ULNRC-04187
TAC NO. MA8052

**DOCKET NUMBER 50-483
CALLAWAY PLANT
UNION ELECTRIC COMPANY
SUPPLEMENT TO REQUEST FOR PROPOSED REVISION
TO TECHNICAL SPECIFICATIONS
TO CORRECT EDITORIAL ERRORS**

MARKED-UP PROPOSED IMPROVED TECHNICAL SPECIFICATIONS

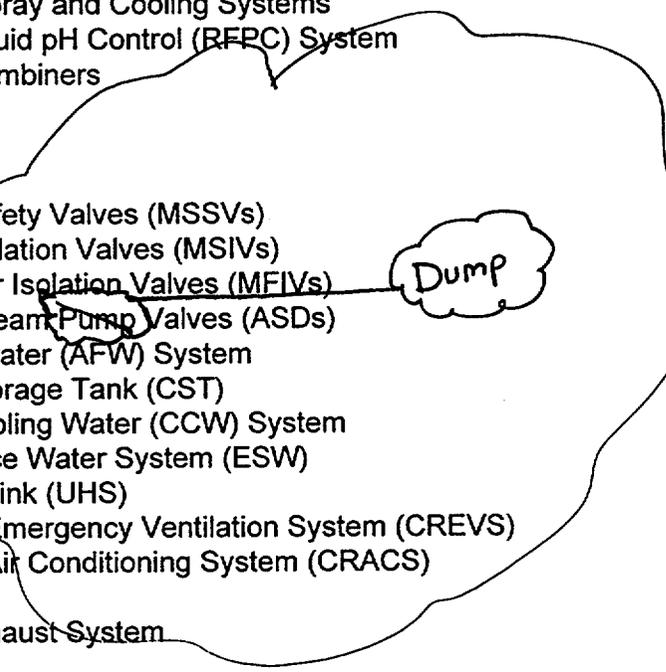
1. **Table of Contents, page 3. Section 3.7.4** - The word "Pump" should be "Dump". The Table of Contents was not originally provided in the ITS submittal in ULNRC-3578 dated May 15, 1997. The Table of Contents was provided in the certified copy of ITS transmitted in ULNRC-4044 dated May 27, 1999. The section title for Section 3.7.4 in the Table of Contents includes the word "Pump", when the correct word should be "Dump".

T/S 1.1, page 1.1-6

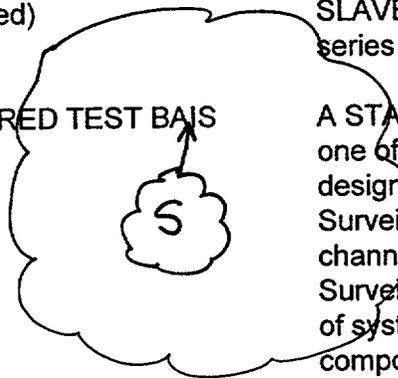
1. **Page 1.1-6.** Under 1.1 Definitions, the Term, STAGGERED TEST BAIS, the word “BAIS” should be corrected to “BASIS”. This word is misspelled in the certified copy due to a typographical error.

T/S 3.4.15, page 3.4-37

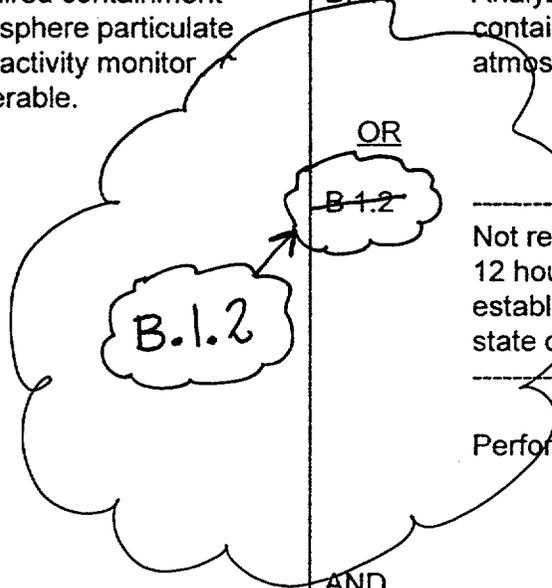
2. **Page 3.4-37.** Under REQUIRED ACTION, CONDITION B, the label “**B 1.2**” is missing the period between the B and the 1. The REQUIRED ACTION label is corrected to “**B.1.2**”. The omission of the period in the certified copy is due to typographical error.
